## Wild Grains Solar Project

Case No. 21-0823-EL-BGN

## **WILD GRAINS SOLAR, LLC'S RESPONSE TO STAFF'S December 15, 2021, DATA REQUEST**

Residences with a Direct Line of Sight

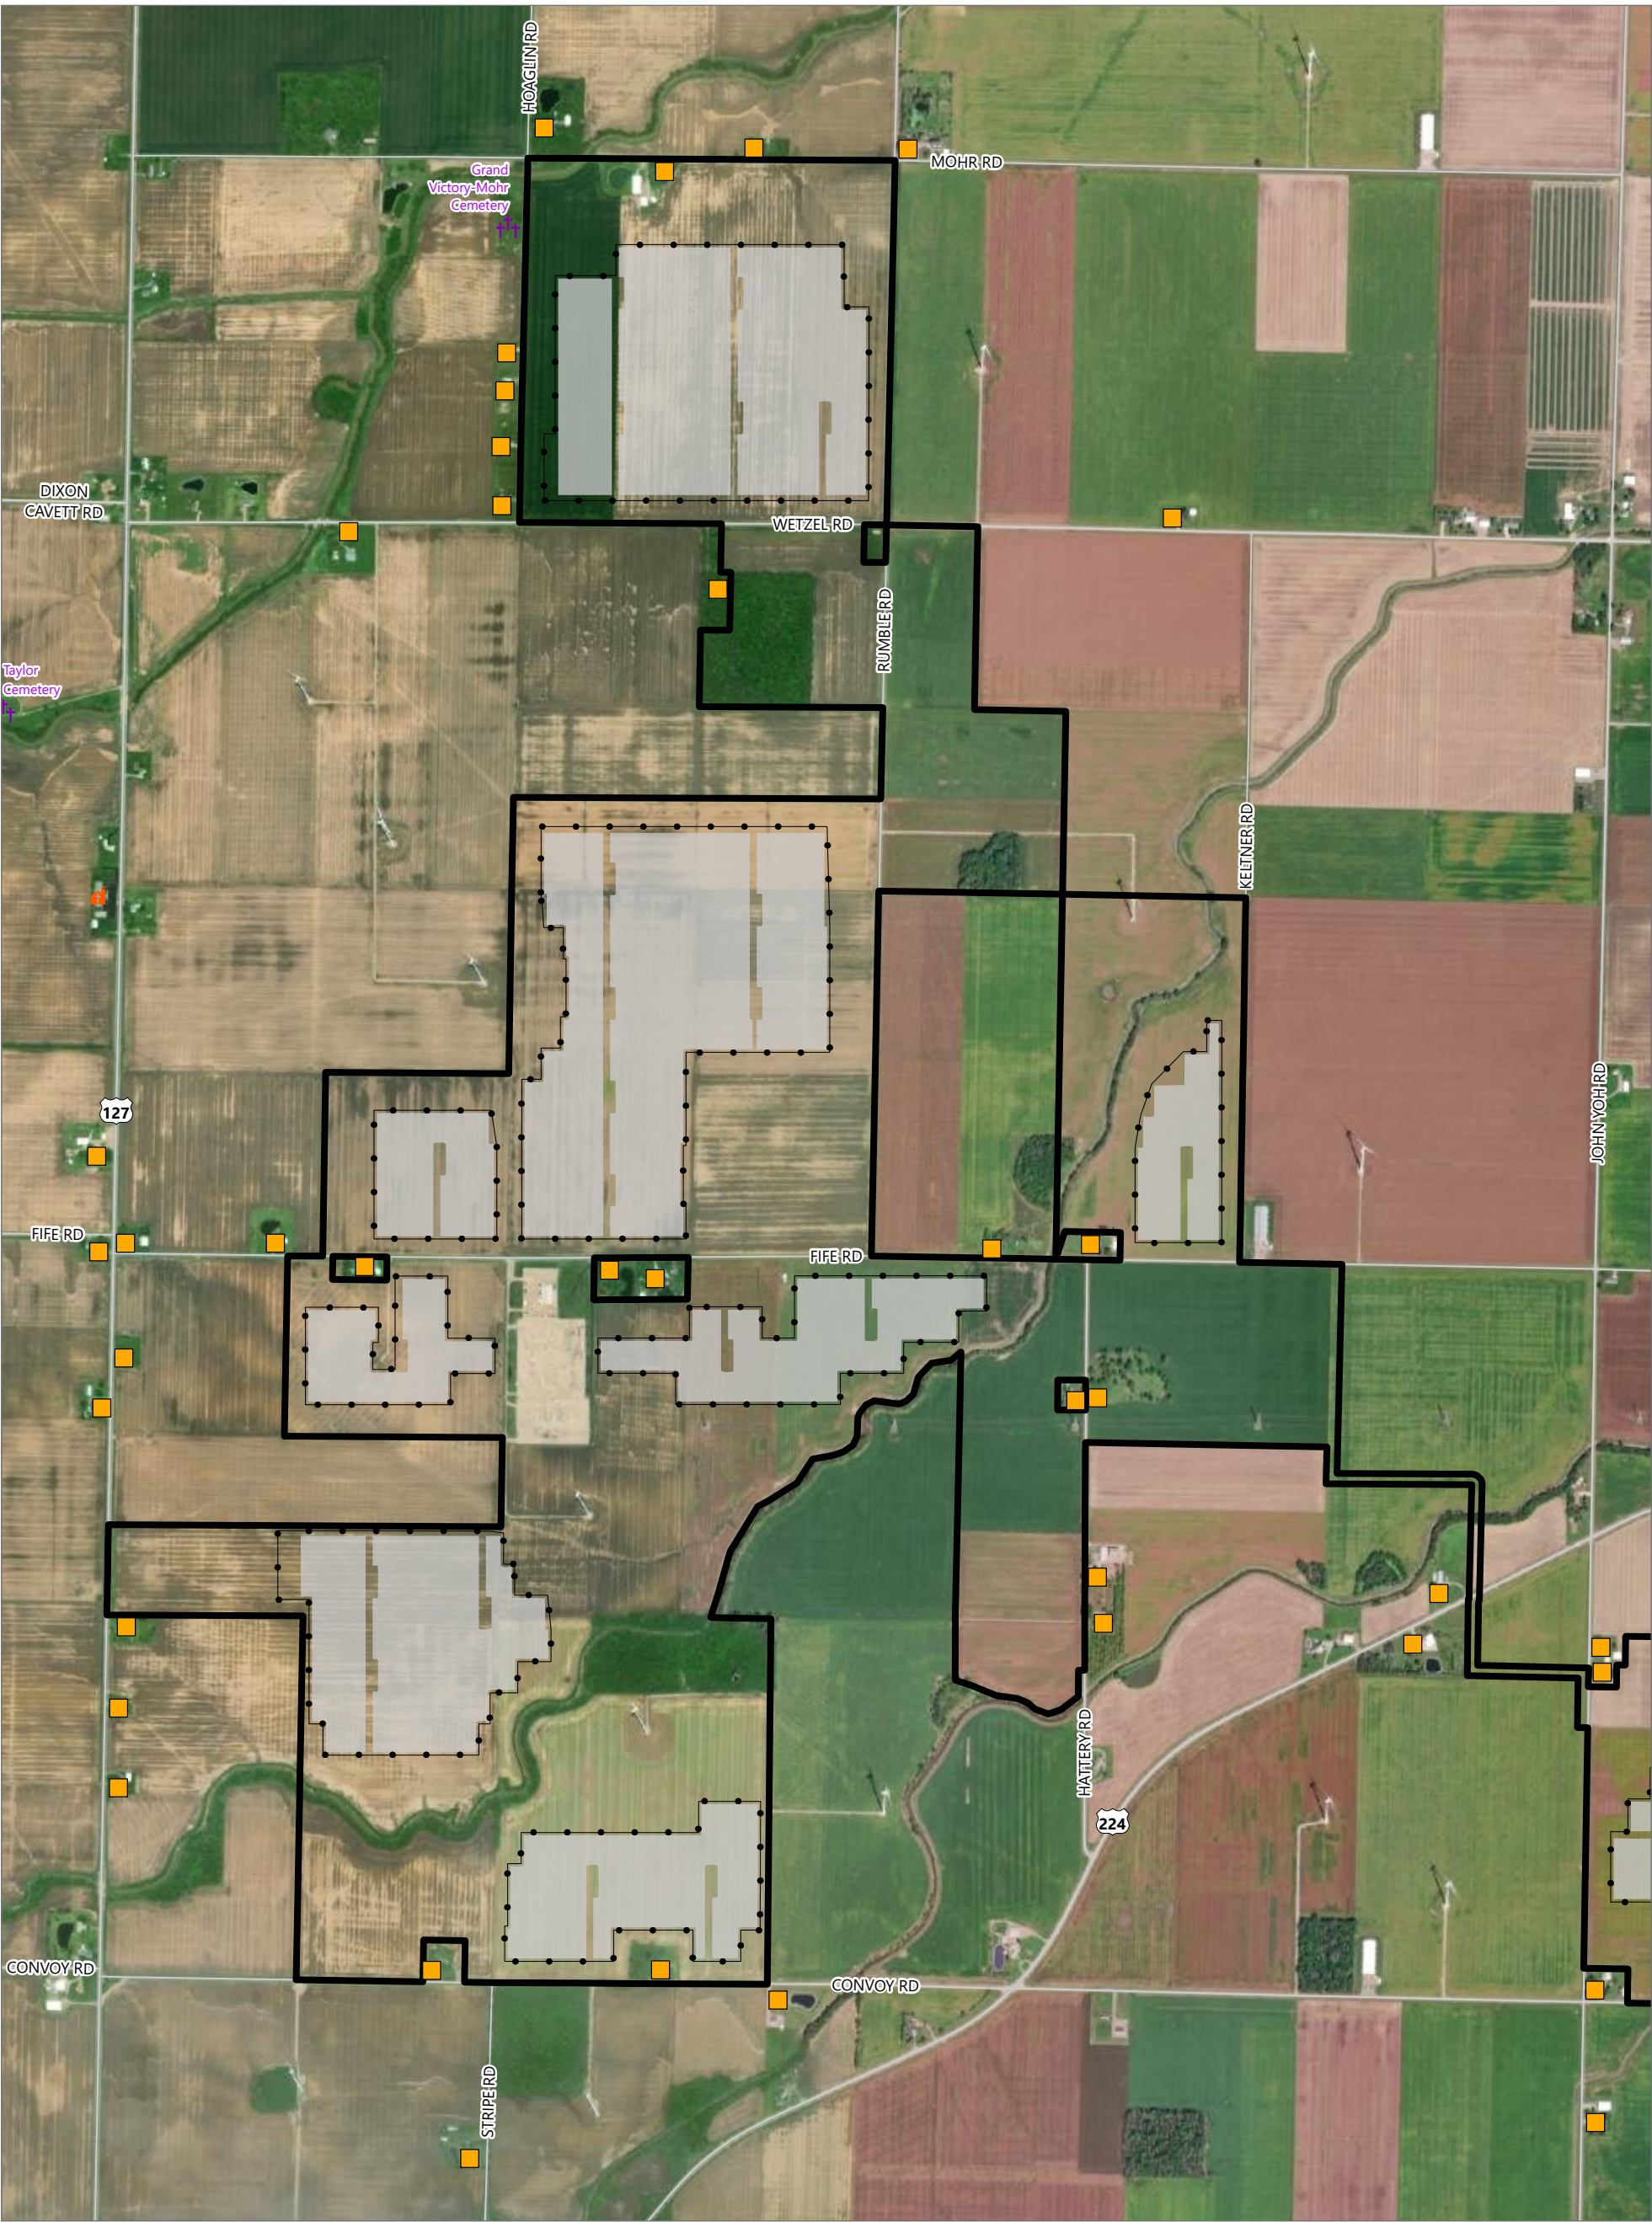
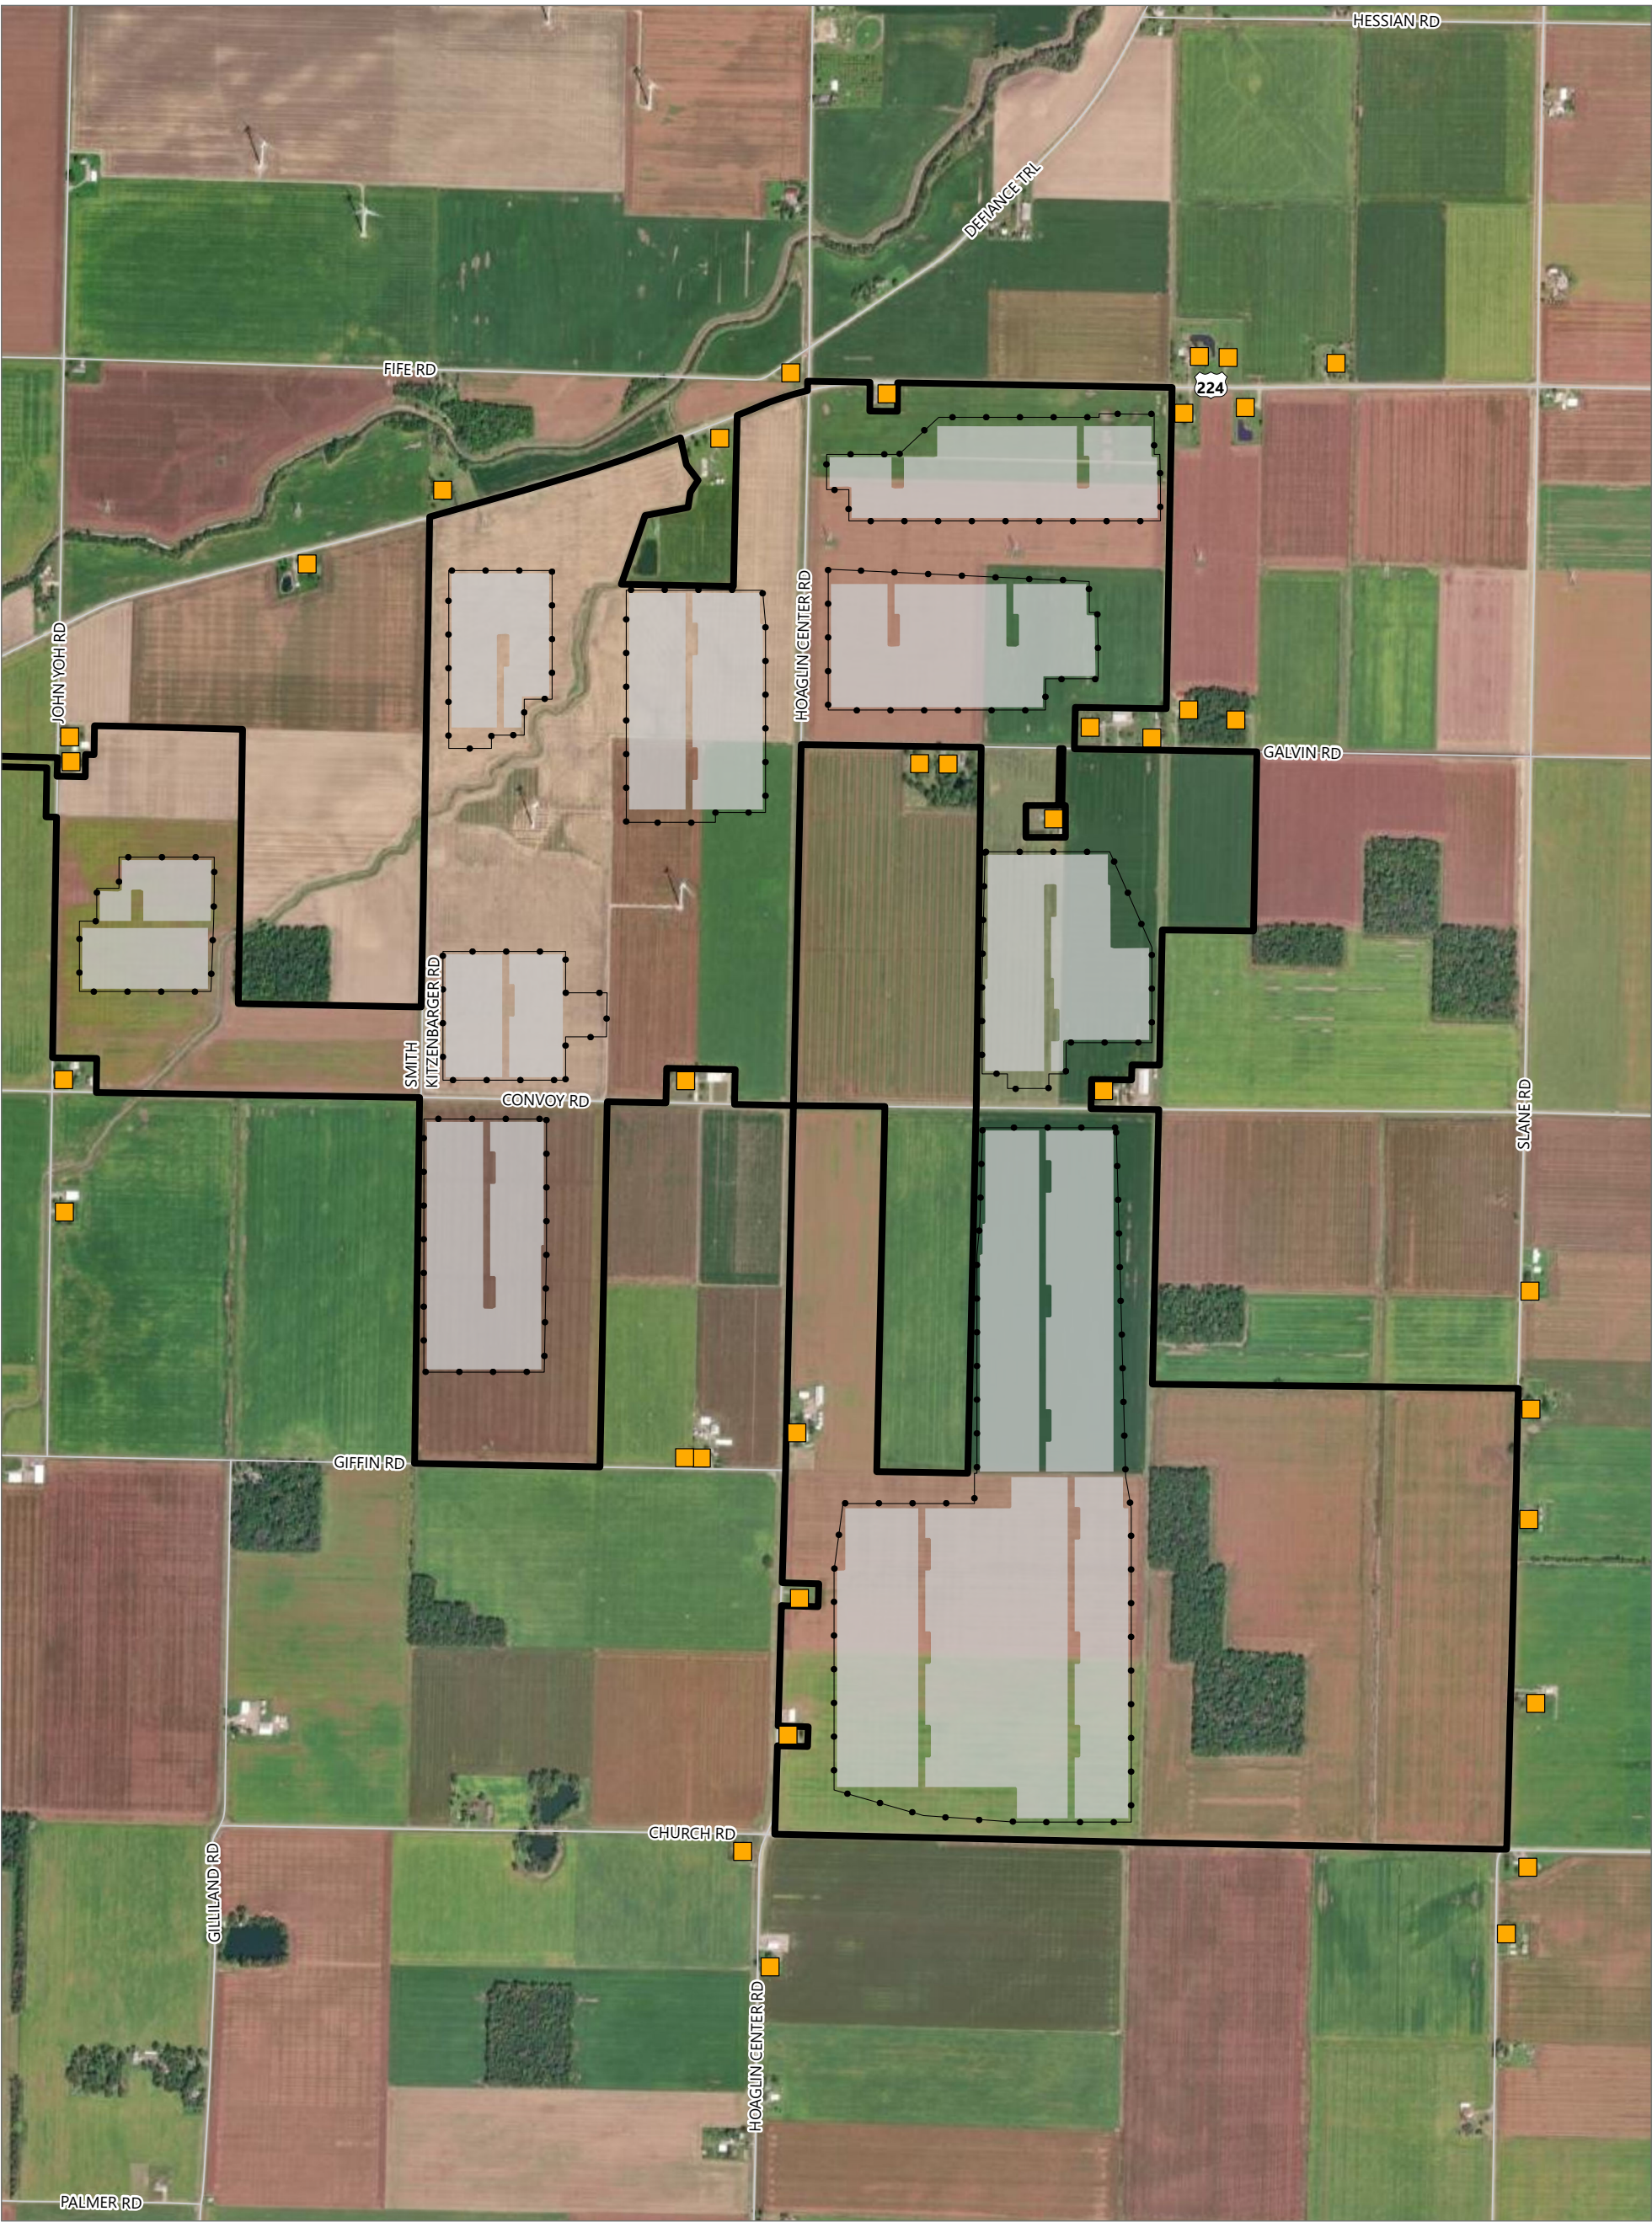
- 1. Provide a large-scale map which depicts participating and non-participating residences that have a direct line of sight to the facility boundary. This map should be superimposed upon the Applicant's proposed landscaping mitigation map. Identify and label nearby adjacent roads, recreational facilities, schools, cemeteries, and any other sensitive land uses.**

A map depicting residences with a direct line of sight to the facility boundary is attached. Direct line of sight was determined based on aerial imagery, and it should be noted that actual views from residences to the project may vary based on the time of year and any changing conditions in the vicinity of the Project.

Wild Grains Wind Speed Distribution 12/31/1996-03-31/2020

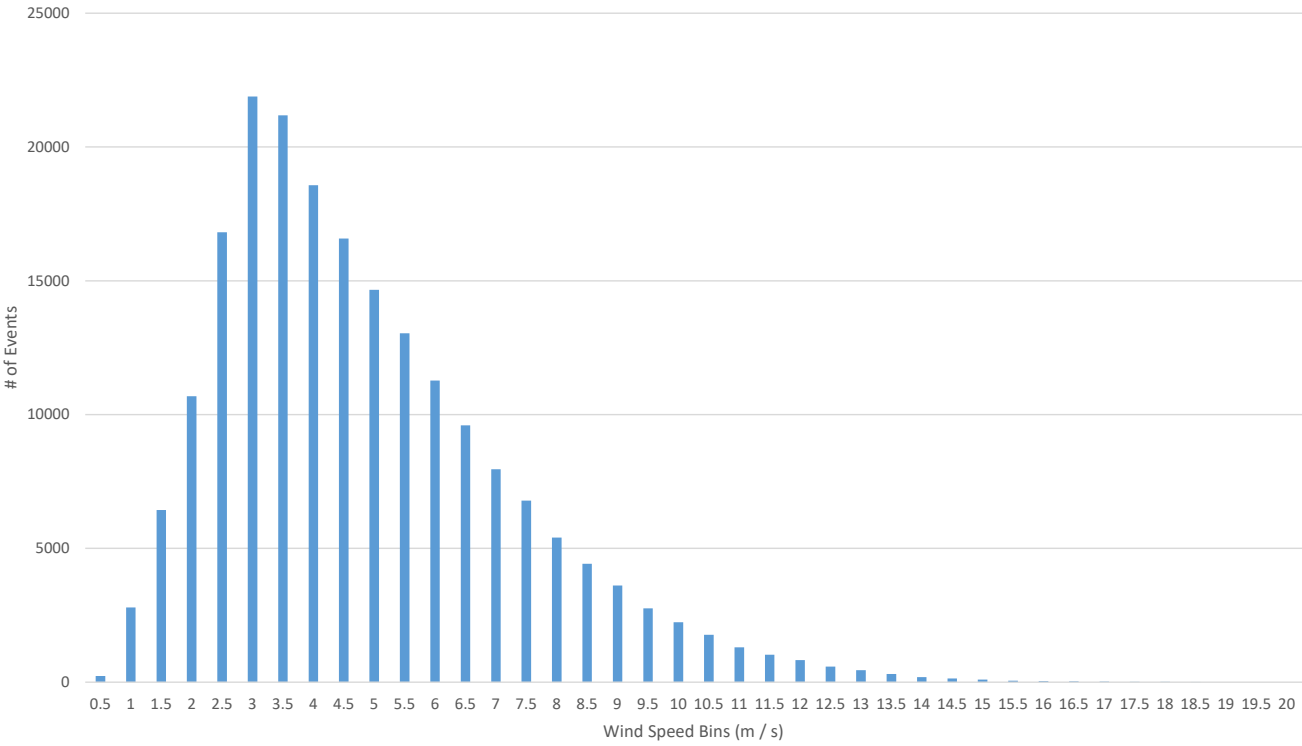
- 5. In accordance with the Rule 4906-4-08 (A)(6), please provide a tabulation of wind velocities and frequency or probability of occurrence for the Project area. A tabulation of observed wind speeds and their frequencies or probabilities of occurrence obtained from nearby airports or weather stations, would be suitable. Actual wind speeds are much more useful and desirable than average wind speeds.**

A table and a graph of wind speed distribution data are attached. The information provided is derived from a compilation of hourly wind speed measurements from December 31, 1996, through March 31, 2020. Because of the size of this dataset, it will have to be provided electronically, if Staff desires to review it. The source of the data is Vaisala 2.1.3, which is a satellite-based solar irradiance dataset (see: <https://www.3tier.com/en/support/solar-online-tools/what-vaisala-21-dataset/>). Vaisala uses a particular
